ADDENDUM #1

SUBJECT: Emergency Generator Installation at Woodson Food Services Warehouse (MMB-088-24)

**WOODSON FOOD
SERVICES
GENERATOR**

E101

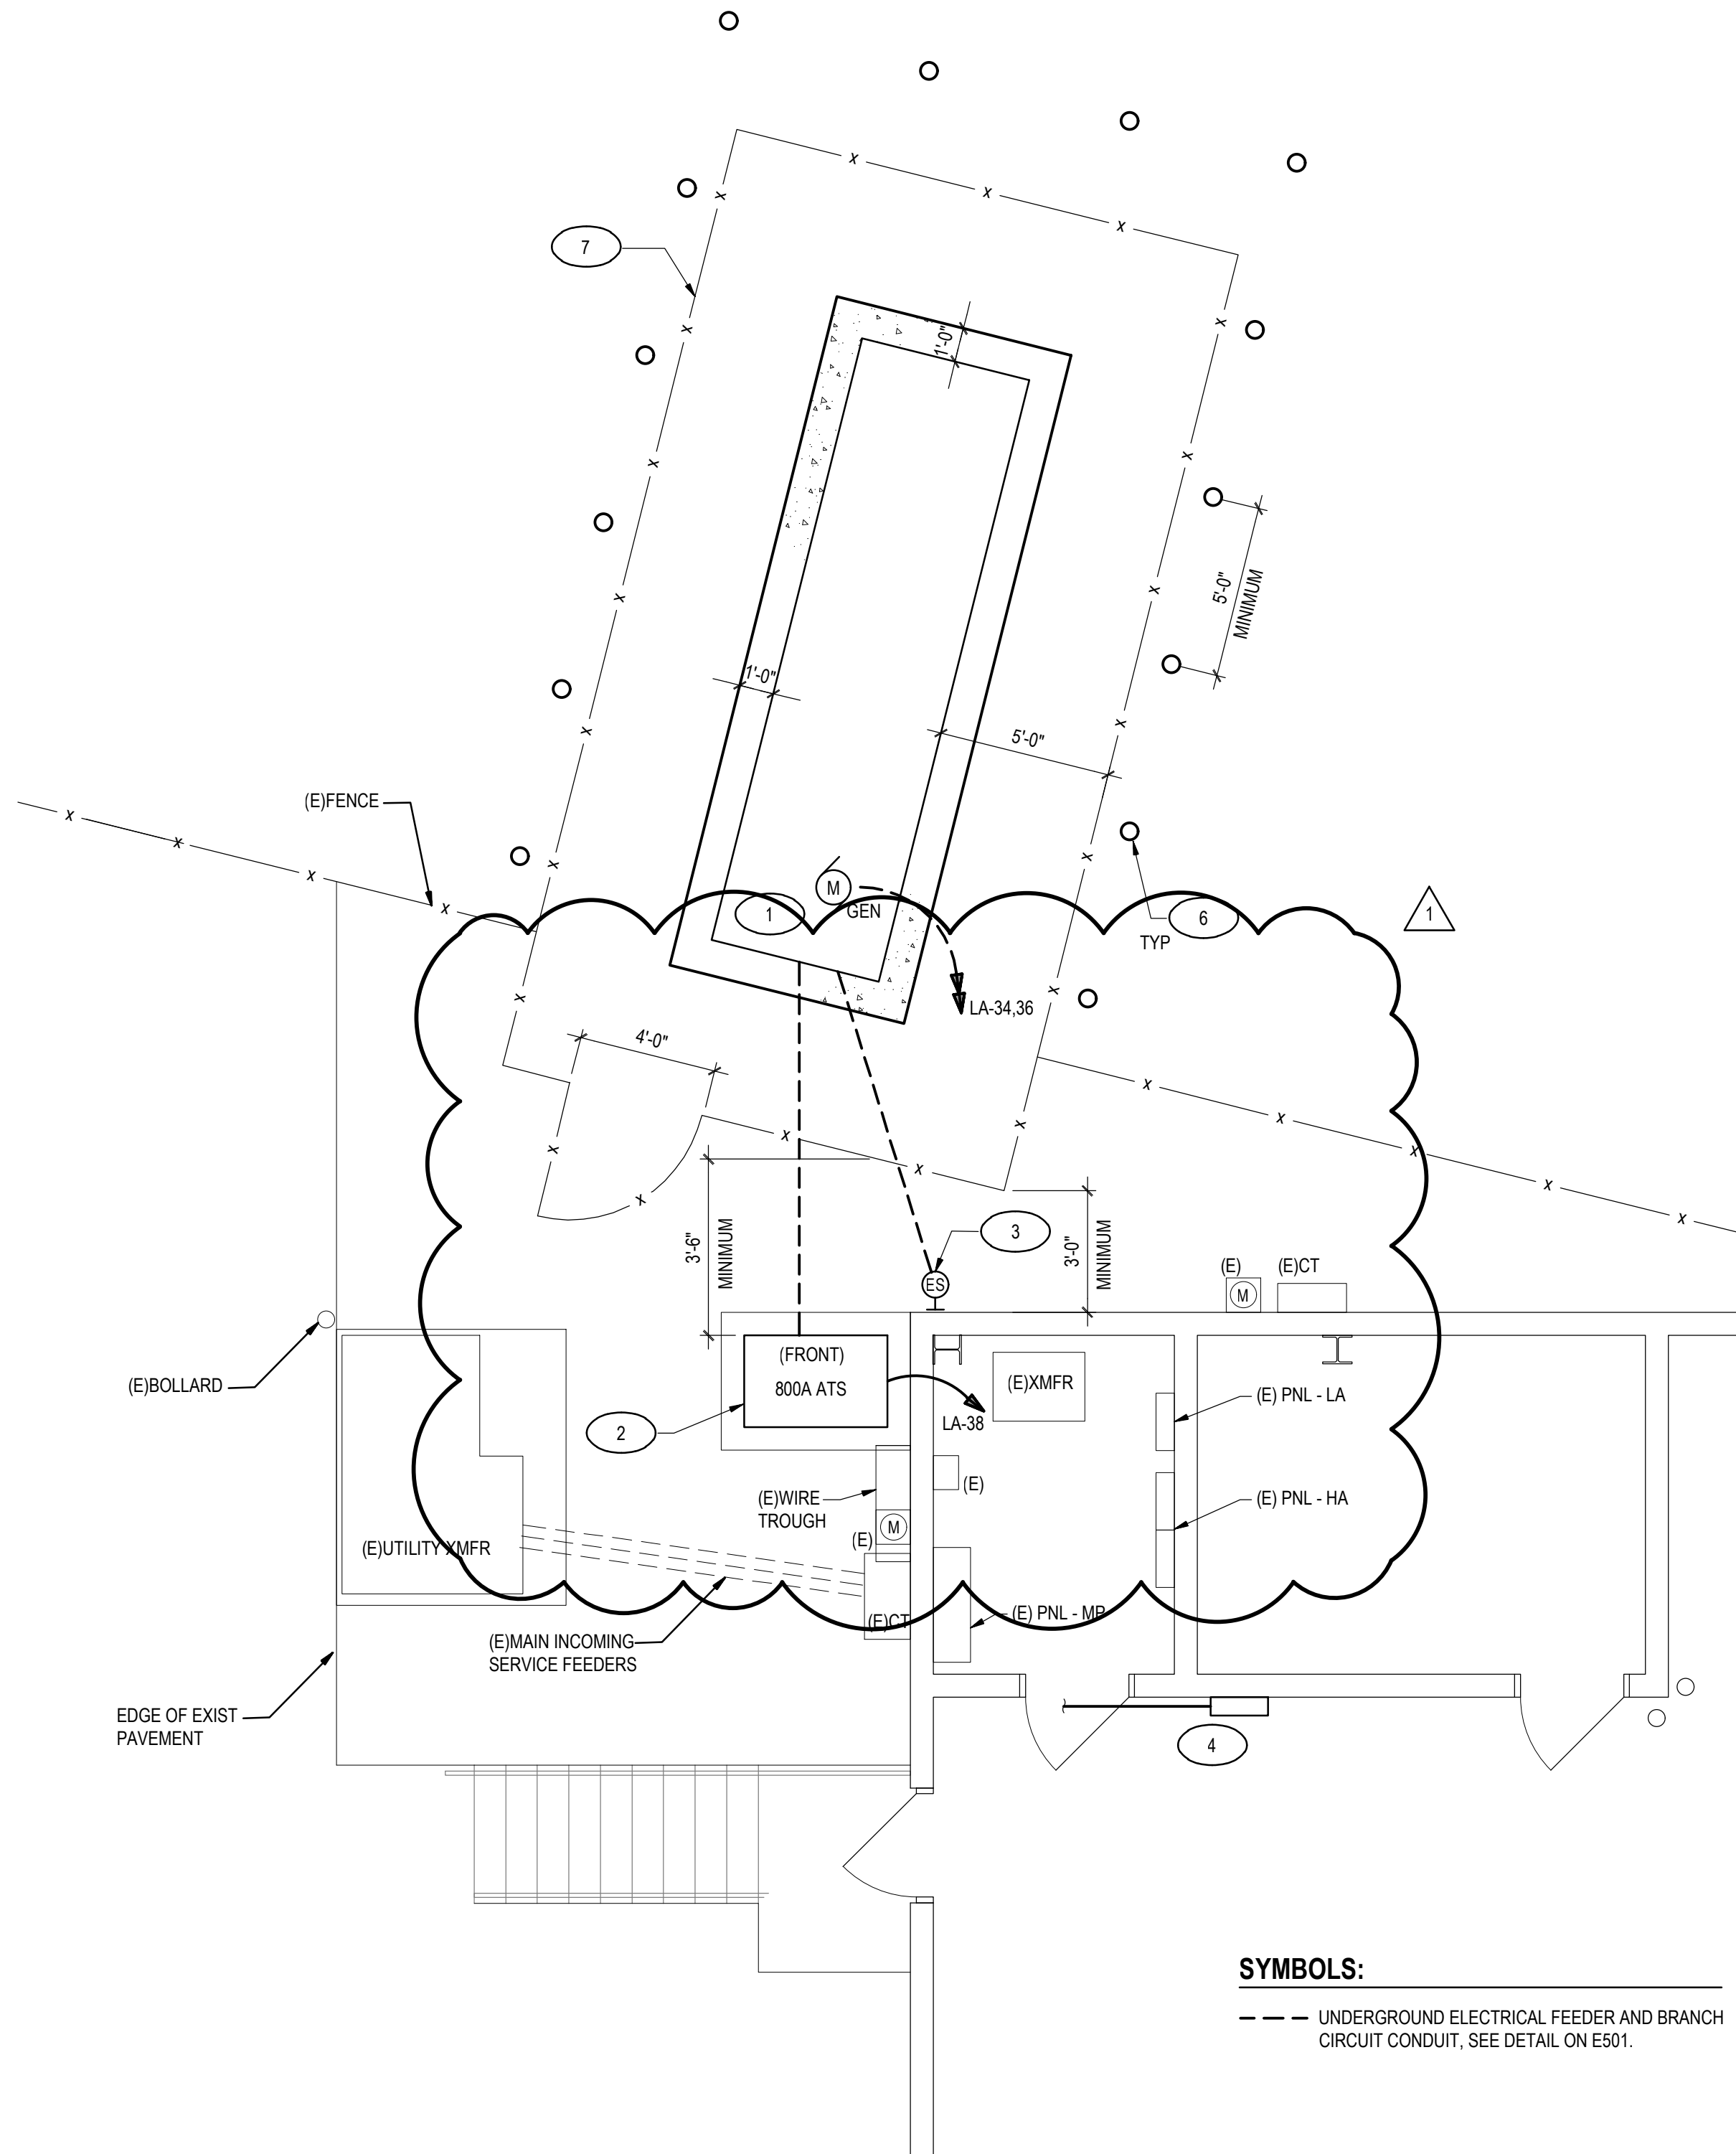
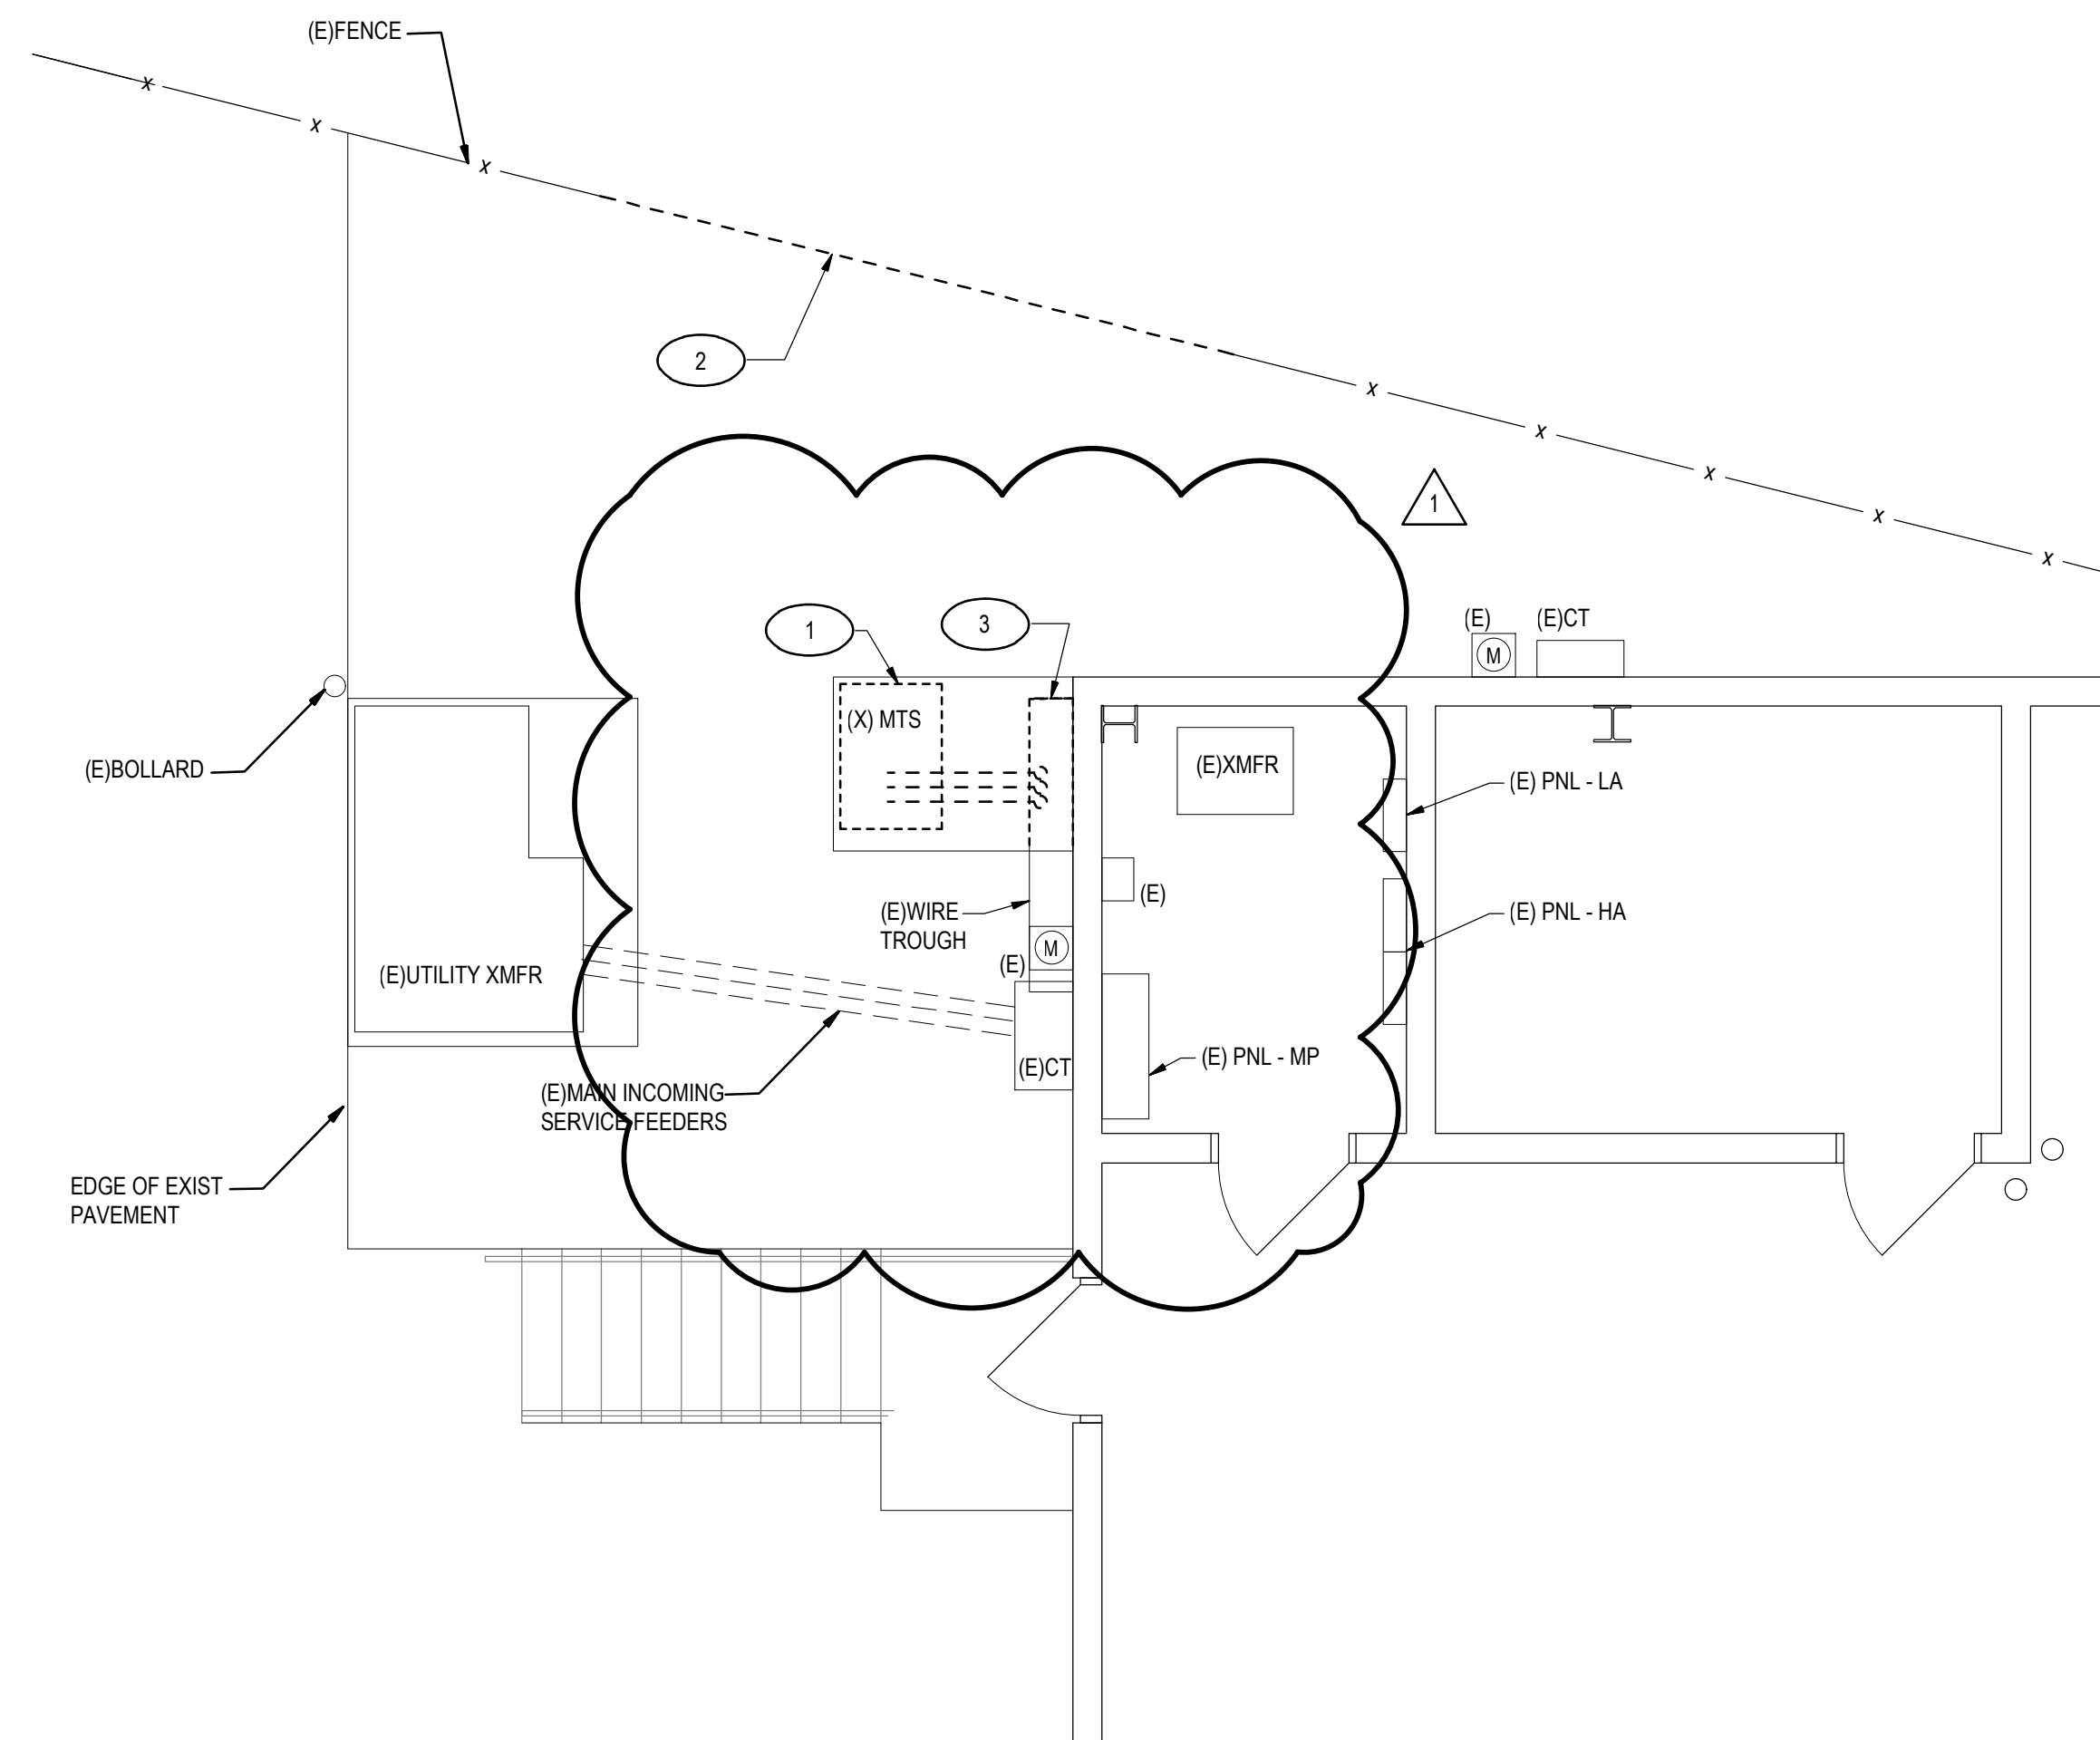
- Q2. Do you want the contractor to re-route 3 sets of (4) 300 KCMil, (1) #2/0 Ground in 3" Conduit from existing CT to New ATS? In turn the existing load side wire from MTS(X) to be used as load side for New ATS appear not to be long enough to reach the Main Breaker in Panel MP. Do you want these Feeders extended or replaced with no splices?

The drawings do not show the actual configuration for this project. The exterior pad mounted equipment is not a MTS as the drawings show. It is essentially a switchboard section with an 800A breaker KIRK keyed in with Panel MP main breaker. The drawings mistakenly have the service feeders shown to the "MTS" and the load leaving the "MTS" to the Panel MP. The "MTS" actually only has one feeder to Panel MP. The service feeder goes directly to Panel MP.

- A1&2 Yes, incoming normal power feeders will need to run from existing CT to new ATS [3 SETS of (3) #300 KCMIL+(1) #2/0 G-N IN 3" C]. Then new feeders from the load side of new ATS to existing panel MP. See attached revised E101 and E601.**

A6. See attached revised E101, E501 and E601. The generator pad size will need to be coordinated with the purchased equipment, once submittal approved, as indicated on drawings. That will be on the contractor to coordinate during construction.

E501

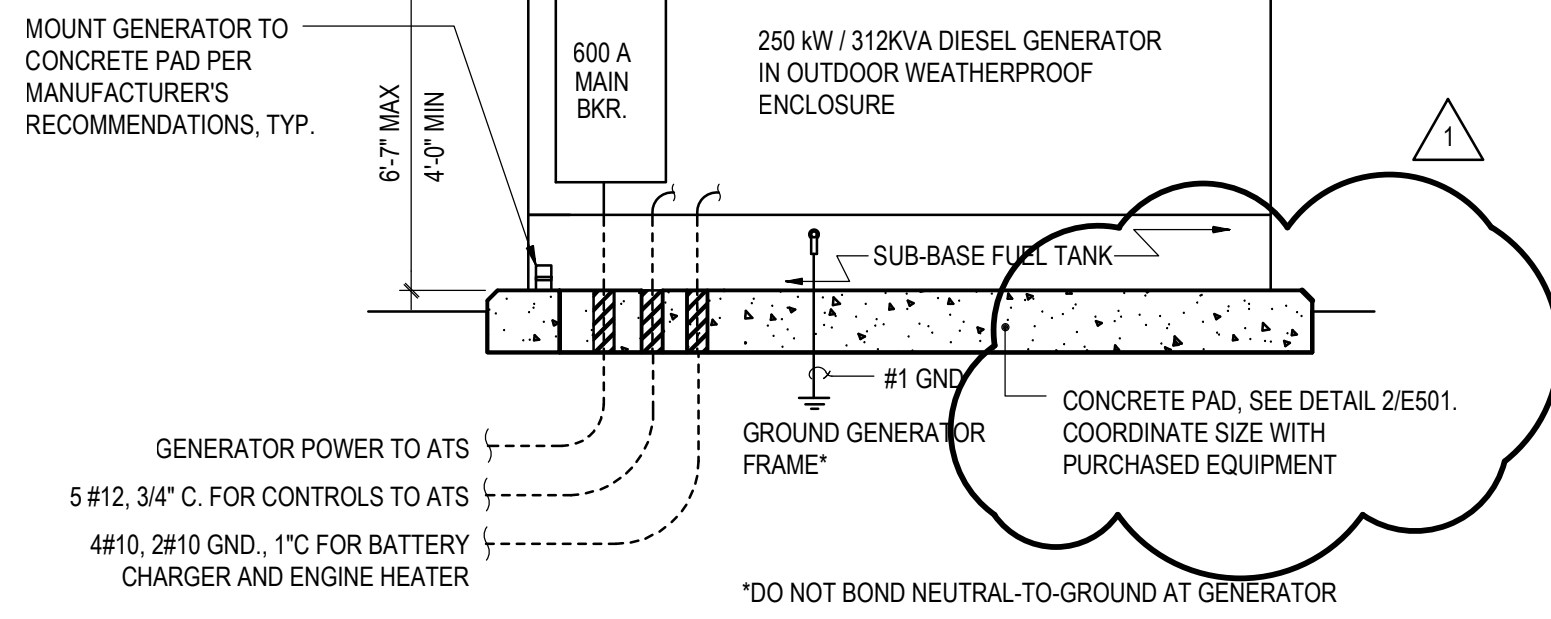
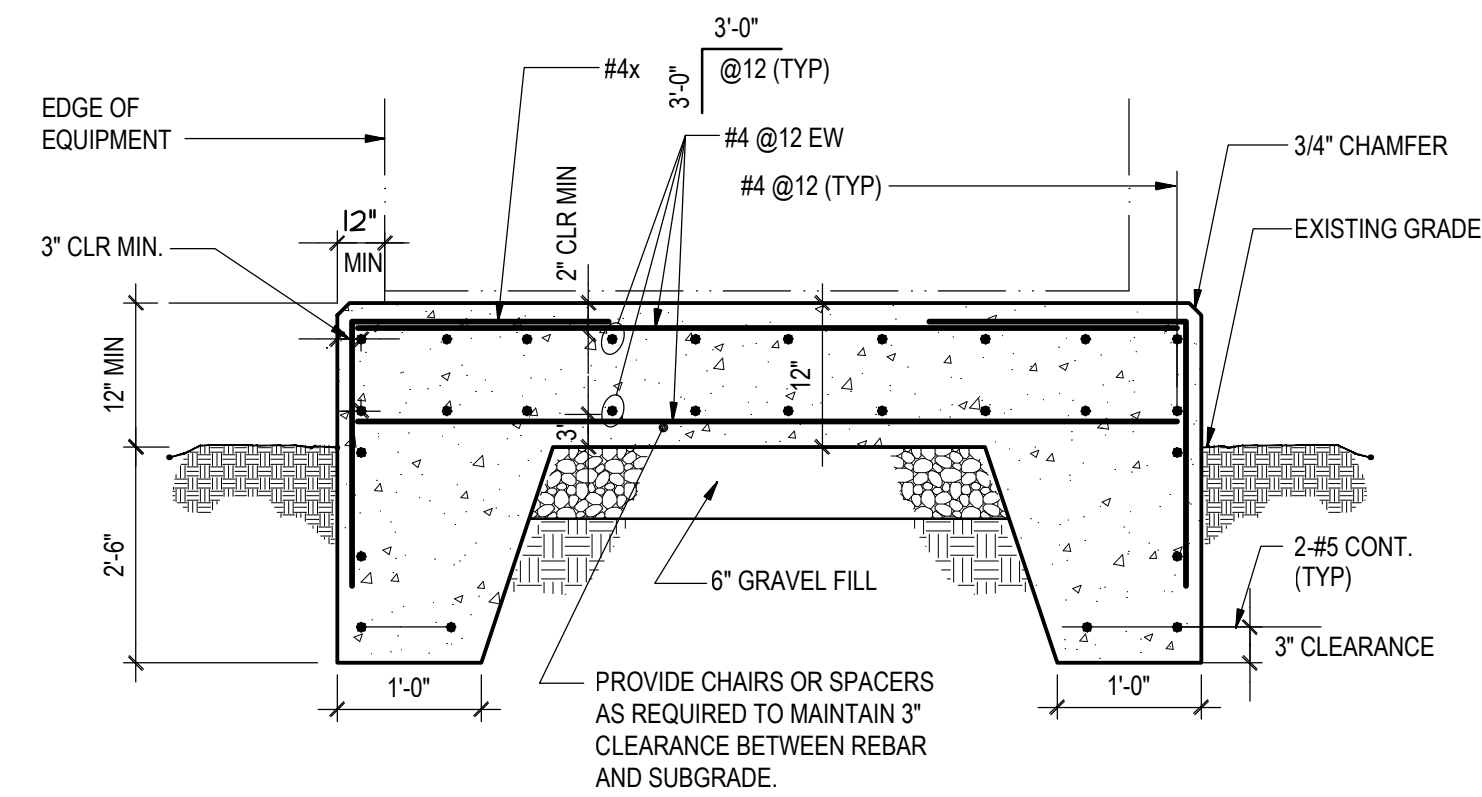
Q6. The drawings will have to be modified for the unit we will be proposing. The generator we are proposing is 18.5' long 4 foot longer than the drawing is showing.

Chris stated that he would like the sides 4 foot wider than the generator. This is not shown on the drawing?
